Subject: TCL (E17D041D) Comment Responses

arcLINE Architectural Design LLC has reviewed and responded to comments generated on 03-26-2024. Please see comment and response below.

AS101

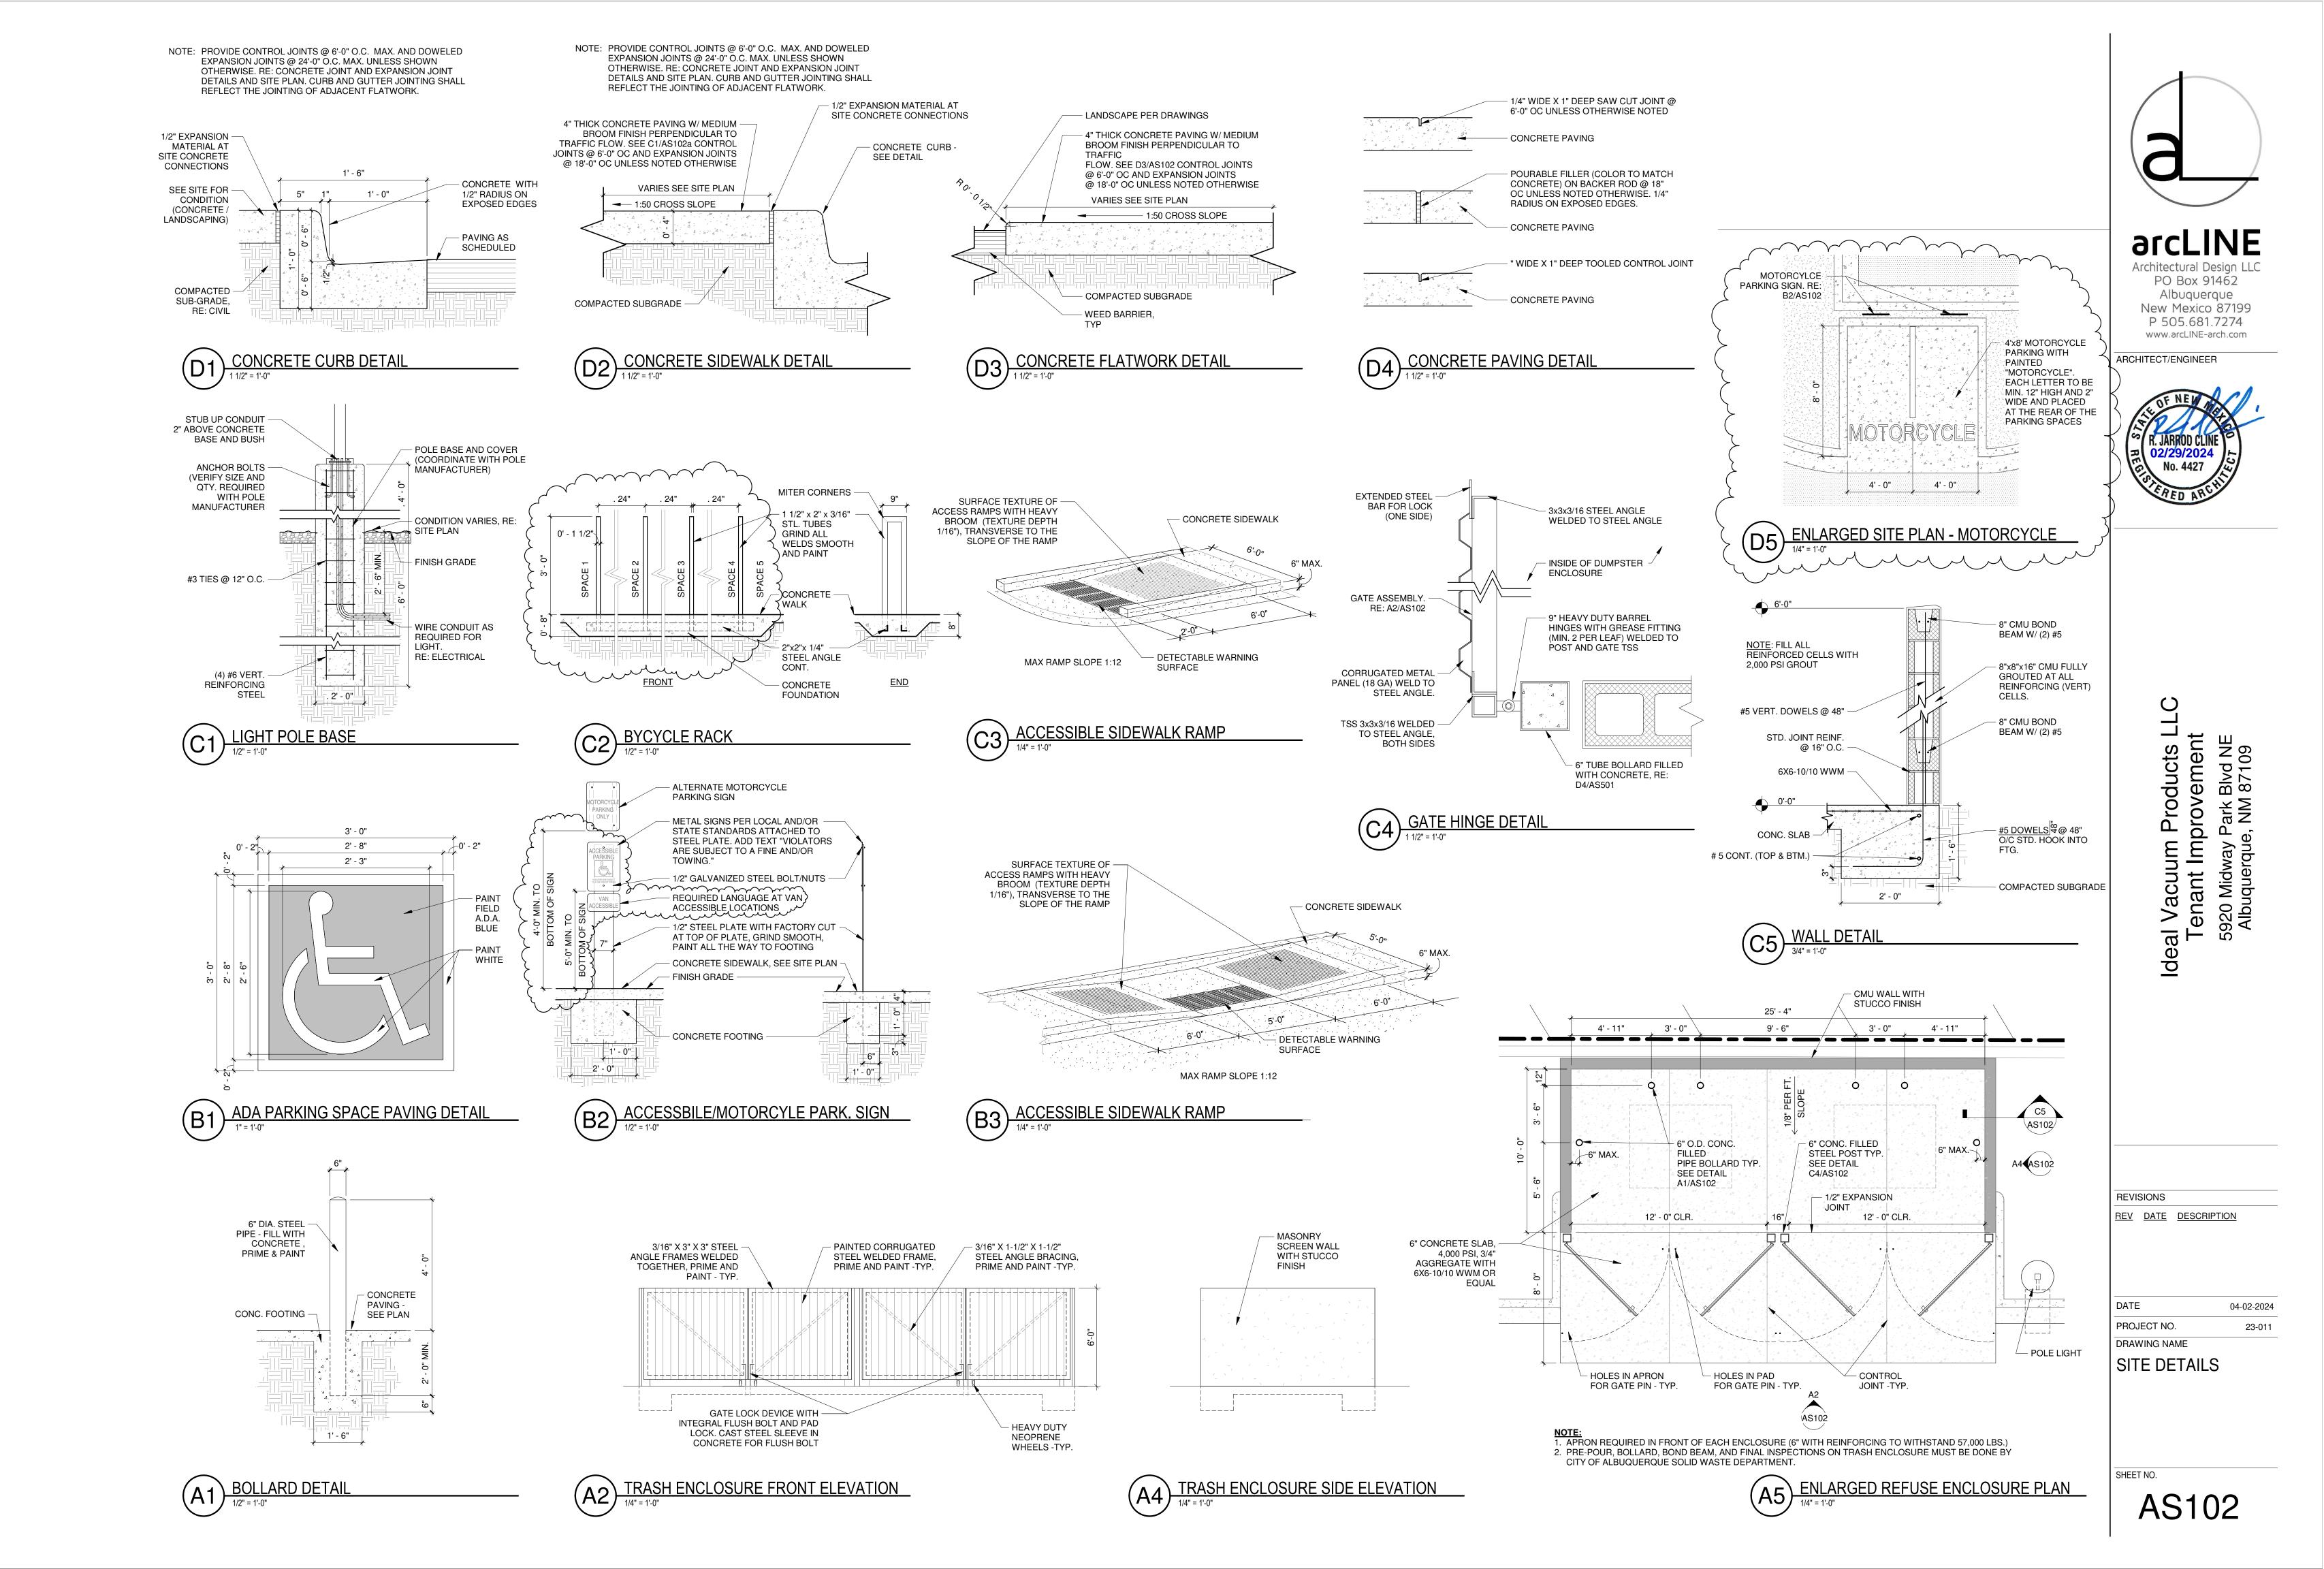
- 1. It appears the keyway in the North parking lot may be 5' deep due to the 4' radius, but please clarify with a depth dimension.
 - a. A dimension has been added to the site plan sheet AS101.

- 2. Provide drive aisle widths west and north of the building. The north-south aisle closest to the building does not appear to be the minimum of 22' wide for 2-way traffic.

- 3. The loading dock in the front of the building may create conflicts with the retail/office circulation in the parking lot. Provide the size of the vehicle that will be using the Loading Dock and show delivery vehicle travel pattern. This will help determine whether the loading dock will need to be moved to the back of the building/ separated from the retail/office circulation.

- 4. The southern curb return of the southern drive entrance does not tie properly/provide continuous radius to the curb ion Midway Park Blvd. It should look like the northern curb return. This entrance will have to be shifted north.

- 5. Provide sidewalk widths. The sidewalk along Midway Park Blvd is to be a minimum of 5' wide.
 - a. Dimensions have been added to the site plan sheet AS101.

- 6. Provide parking stall widths.
 - a. Dimensions have been added to the site plan sheet AS101.
- 7. Provide accessible aisle width and depth.
 - a. Dimensions have been added to the site plan sheet AS101.

- 8. A 6 ft. wide ADA accessible pedestrian pathway is required from the Public sidewalk to the building entrance(s). Please clearly show this pathway and provide details.

- a. Dimensions have been added to the site plan sheet AS101.
- 9. For the van accessible parking space, add the "Van Accessible" sign (see attached image). I think the "Van No Parking" pavement markings is misleading and it is non-standard, so these pavement markings can be removed. I attached an image for the DPM.

- a. Detail B2/AS102 has been revised.
- 11. Please discuss what appear to be two bridges across the drainage channel. They do not appear to be for vehicles, but please state the purpose/usage. Since the southern portion is on the adjoining lot, written approval (email or letter) from that property owner is required.

- 12. Provide the widths of the proposed drive entrances.
 - a. Dimensions have been added to the site plan sheet AS101.
- 13. Provide the size of the vehicle to determine curb return radii of the drive entrances.

- a. The Fire Marshal and Solid Waste Department approvals are attached.
- Add a Note that broken or cracked sidewalk in the City ROW shall be replaced per COA STD DWG 2430.

- a. Detail C2/AS102 has been revised to indicate the proper spacing.
- 17. Show the clear sight triangle and add the following note to the plan: "Landscaping and signage will not interfere with clear sight requirements. Therefore, signs, walls, trees, and shrubbery between 3 and 8 feet tall (as measured from the gutter pan) will not be acceptable in the clear sight triangle.

- a. Dimensions have been added to all drive aisle widths, including the aisles closest to the building which is now indicated at 22'. See attached sheet AS101.

- a. A straight box truck with 26-foot bed or shorter will make deliveries to this location. Any deliveries on a semi-truck is delivered to a different location and brought to this location via a box truck. A 35' box is indicated at the loading dock to show minimal interference with the adjacent circulation.

- a. The drive has been shifted north to allow the proper radius and accessible sidewalk ramp. A steel channel cover has been added to the project to allow the flow of water without pedestrians walking through it. The adjacent sidewalk will be replaced to meet up evenly.

- a. The wording has been removed from the plan sheet AS101.

- a. A note has been added along Midway Park Blvd.
- 16. Detail C2, Bicycle Rack, revise the spacing between the racks as a bicycle parking space is 6' long x 2' wide.

- a. The clear sight triangle and note has been added to the site plan sheet AS101.
- 18. Provide Sheet AS103.
 - a. There is no sheet AS103, the reference was included by mistake. The motorcycle enlarged plan has been added to sheet AS102 detail D5.
